CB13-J-002

## **Safety Recall Oil Pan Heater Extension Cord - #13V-259 (Transport Canada # TC2013-212/213)**

Figure 1 – Optional Oil Pan Heater Cord Location

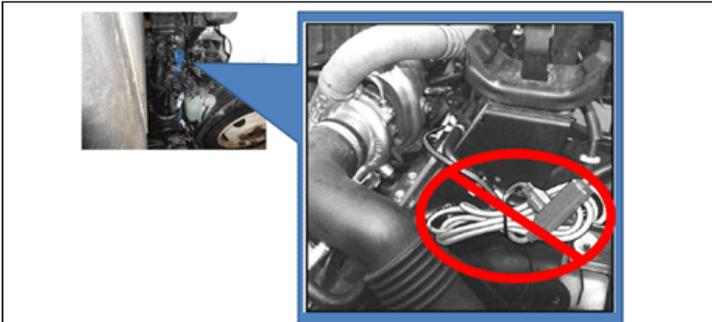
- 1. Locate the blue oil pan heater extension cord and remove it from the vehicle. Cut the extension cord into at least 2 pieces using wire cutters and retain at least one end for warranty part return.

Figure 2 – Dirty, Dusty Plug

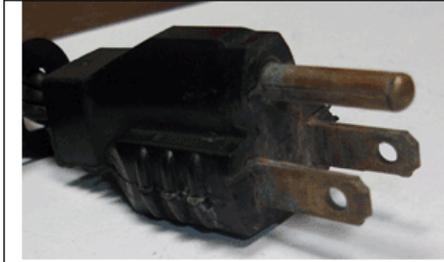
3. Inspect the oil pan heater plug (and block heater cable plug if equipped). Dirt, dust and carbon tracking evidence must be cleaned from the plug terminals (Figure 2). Use a wire brush, emery cloth or medium grade sanding pad (Figure 3) to clean the plug terminals. After cleaning blow away any residual debris with air pressure or electrical contact cleaner.
